UNITED STATES PATENT AND TRADEMARK OFFICE

10/590,284

Office Action Summary	Application No. 10/590,284	Applicant(s) ABUMUSTAFA, ANWAR	
	Examiner AMENE BAYOU	Art Unit 3746

DETAILED ACTION

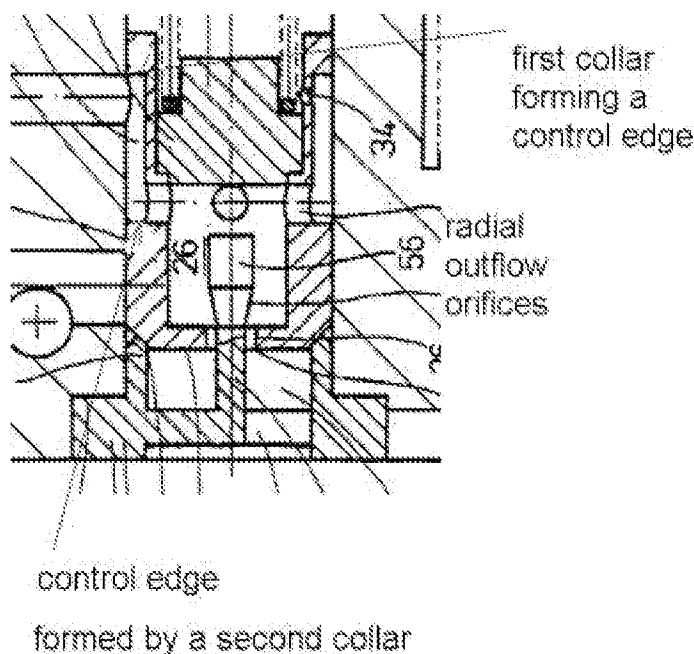
In re claim 7 Nguyen et al. disclose a valve assembly including:

A pump comprising: **a flow-control valve device (figure 1;column 1,lines 5-12)** including a piston **(16;figure 1)** displaceably accommodated within a piston bore , the piston bore having **at least one inflow channel (36)** and **at least one outflow channel (32)** , and the **piston (16)** having an **axial inflow orifice (26)** and a **plurality of radial, lateral outflow orifices (28)** and a **circumferential outflow groove (30)** disposed between **a first collar (see below)** and **a second collar (see below)**, the second collar forming a **control edge (see below)** for an outflowing fluid flow, the **axial inflow orifice (26)** extending cylindrically at least to a beginning of the **radial, lateral outflow orifices (28)** .

Nguyen et al.'s **outflow groove (30)** does not expand in terms of a radial depth on an outer surface of the piston.

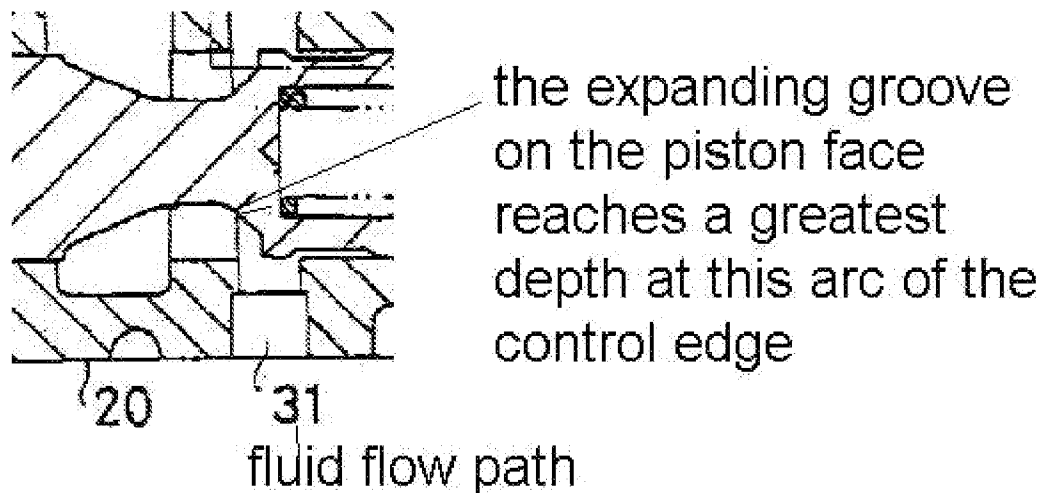
Nirasawa et al. teach a hydraulic valve wherein **a circumferential outflow groove (44; figure 2A and 2B)** expanding in terms of a radial depth on an outer circumference of the piston (40) towards the control edge.

It would have been obvious to one skilled in the art at the time the invention was made to modify the valve of Nguyen et al. by making the circumferential outflow groove to expand in terms of radial depth up to a control edge as taught by Nirasawa et al in order to have smooth flow transition between the discharge orifice and an outlet connection (the curved surface reduces flow resistance and accompanied flow loss is reduced).

The **outflow groove (44; figure 2A and 2B)** expands in a conical form on a piston side and, as the result of a radially, inwardly directed arc, subsequently reaches a greatest depth in a region of the control edge .
